Modification/Change Order No.6

EWP – Oyster Creek Channel Bank Stabilization Phase II

RE: Modification Pricing Request – Realignment of Site 428

SITE PLANS - 428, 429, & 424

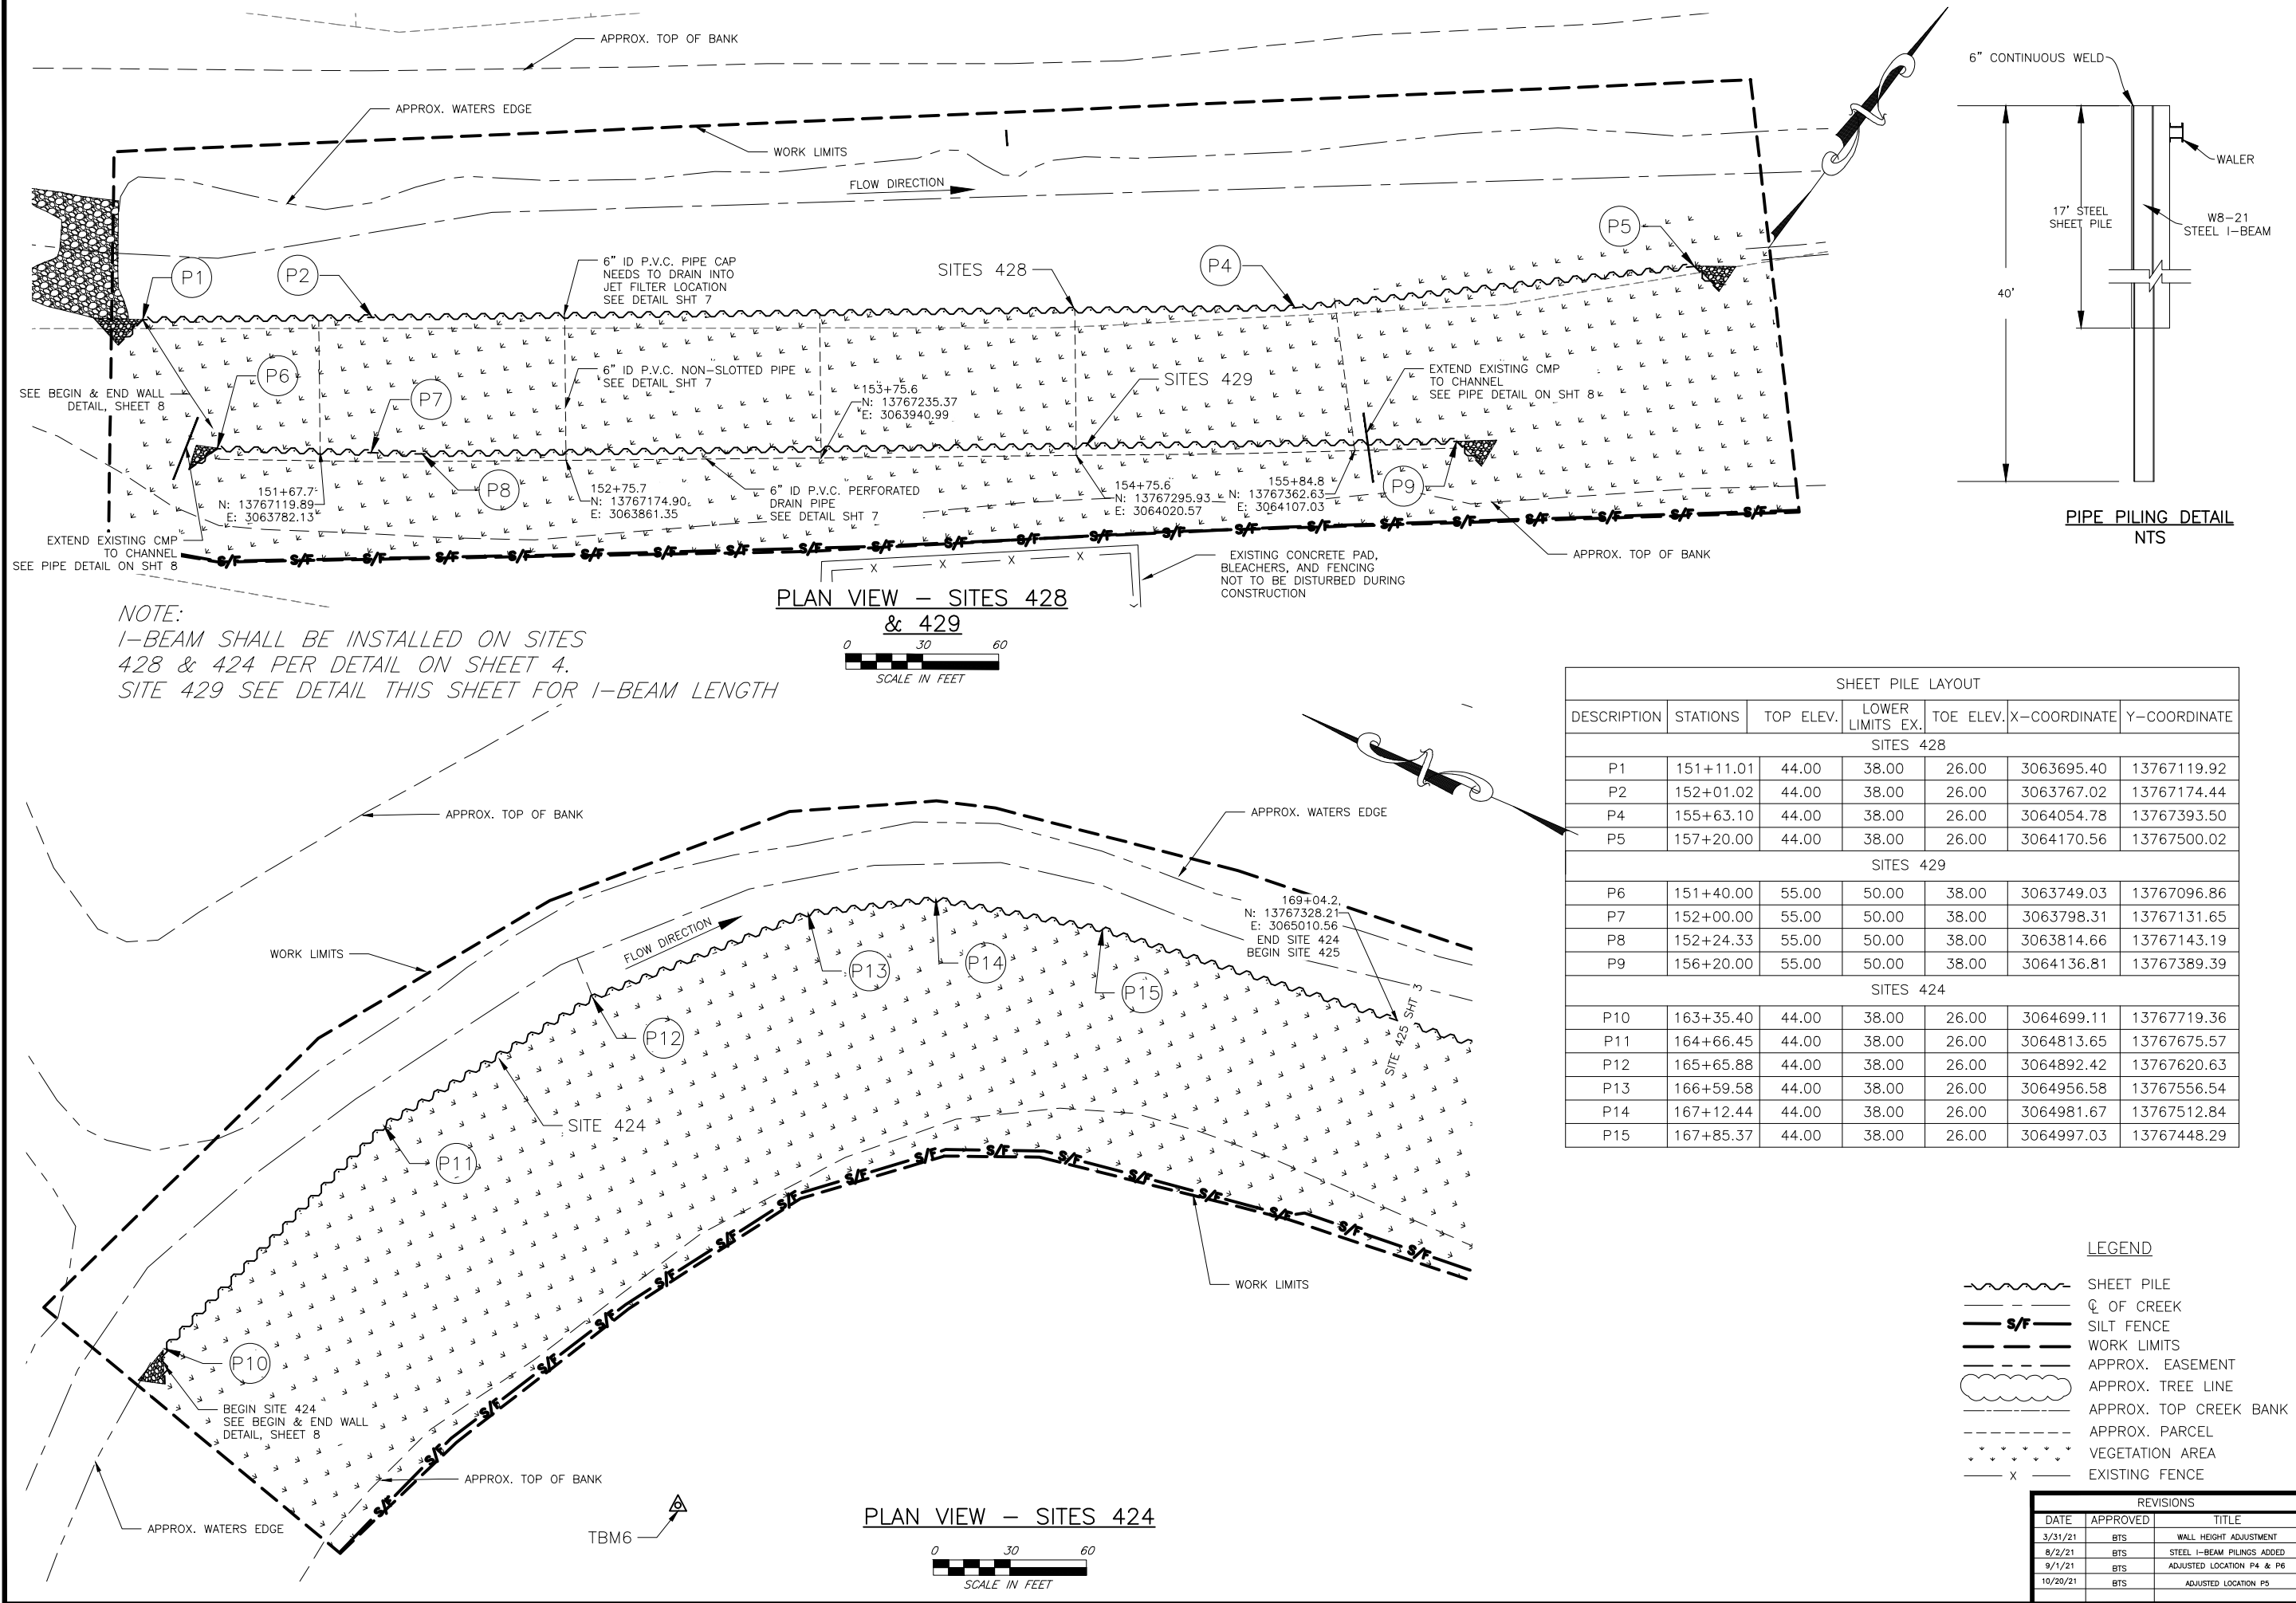
Contractor shall furnish all material, equipment and labor to place relocate the steel sheet pile wall on Site 428 (P4 to P5) as shown on the attached drawing. Materials shall be salvaged and reused to complete the required wall. Compensation for this change is lump sum as shown below.

NBG Constructors, Inc. respectfully submits lump sum pricing of \$47,500 to completely remove and replace approximately one-hundred, fifty-eight (158) feet of completed sheet pile wall to facilitate the revised alignment. The pricing is predicated on being able to reuse all existing materials, except for both the coarse and fine drain fill.

NOTE:
I-BEAM SHALL BE INSTALLED ON SITES
428 & 424 PER DETAIL ON SHEET 4.
SITE 429 SEE DETAIL THIS SHEET FOR I-BEAM LENGTH
